**NOTICE OF APPROVAL OF AMENDMENTS TO THE SEPTEMBER 2015 DELAY  
ATTRIBUTION GUIDE**

The below Proposals for Amendment as submitted by the Delay Attribution Board on 11 February 2016 were approved by the Office of Rail and Road on 17 February 2016.

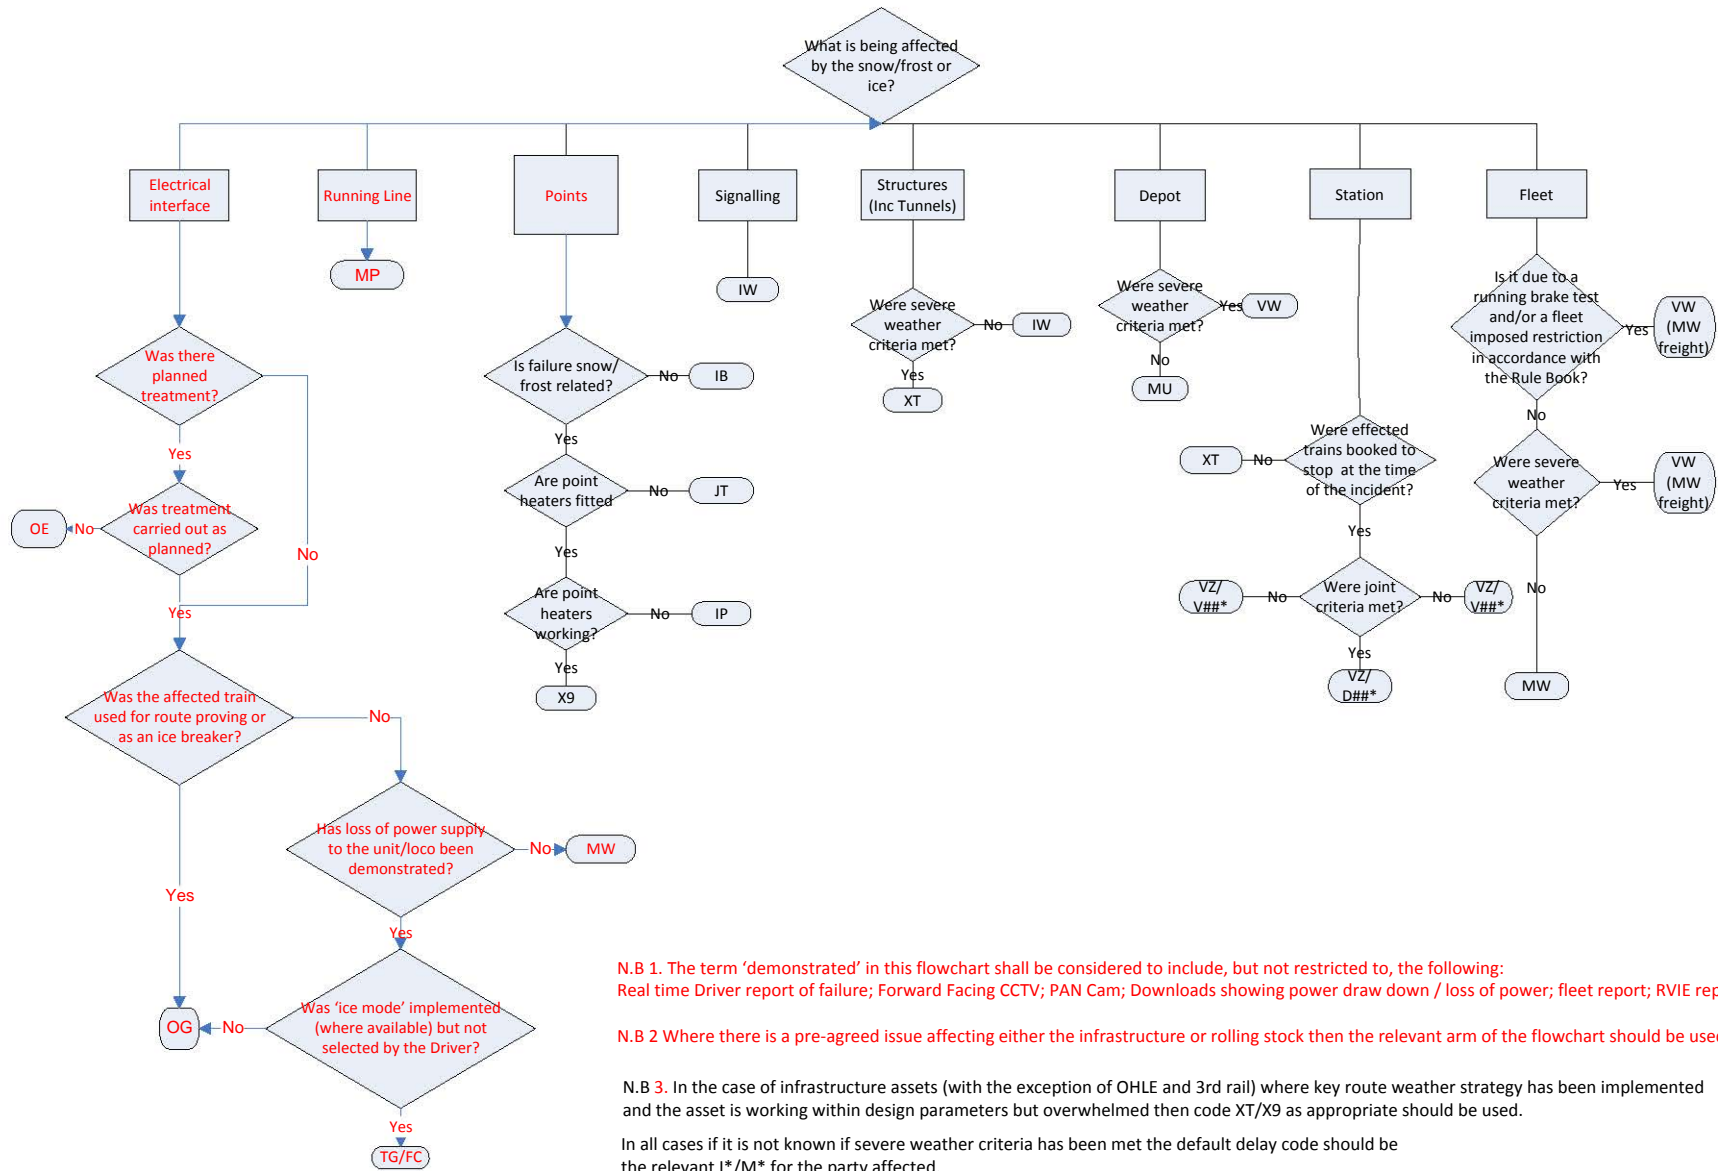
Originators Reference Code / N°	<b>DAB / P264 Ice and OHLE Electrical Interface</b>							
Exact details of the change proposed	<b>Amend SECTION 4.31.2(e) to read:</b> <table border="1" data-bbox="354 891 1136 1137"> <tr> <td>e.</td> <td>Locomotive/EMU ADD activation due to mechanical / Fleet Engineer cause</td> <td>M1</td> <td>Operator of the train concerned (M##*)</td> </tr> </table> <p><b>Add footnote to 4.31.2 to read</b></p> <p>Note: For any weather related OHLE incidents please refer to section 4.40</p> <p><b>Amend 4.40.5d flowchart (as attached below)</b></p> <p>(alterations / additions in red)</p> <p><b>Amend all references in the DAG of 'OLE' to read 'OHLE'</b></p>				e.	Locomotive/EMU ADD activation due to mechanical / Fleet Engineer cause	M1	Operator of the train concerned (M##*)
e.	Locomotive/EMU ADD activation due to mechanical / Fleet Engineer cause	M1	Operator of the train concerned (M##*)

N.B 1. The term 'demonstrated' in this flowchart shall be considered to include, but not restricted to, the following:  
 Real time Driver report of failure; Forward Facing CCTV; PAN Cam; Downloads showing power draw down / loss of power; fleet report; RVIE report.

N.B 2 Where there is a pre-agreed issue affecting either the infrastructure or rolling stock then the relevant arm of the flowchart should be used.

N.B 3. In the case of infrastructure assets (with the exception of OHLE and 3rd rail) where key route weather strategy has been implemented and the asset is working within design parameters but overwhelmed then code XT/X9 as appropriate should be used.

In all cases if it is not known if severe weather criteria has been met the default delay code should be the relevant I\*/M\* for the party affected.
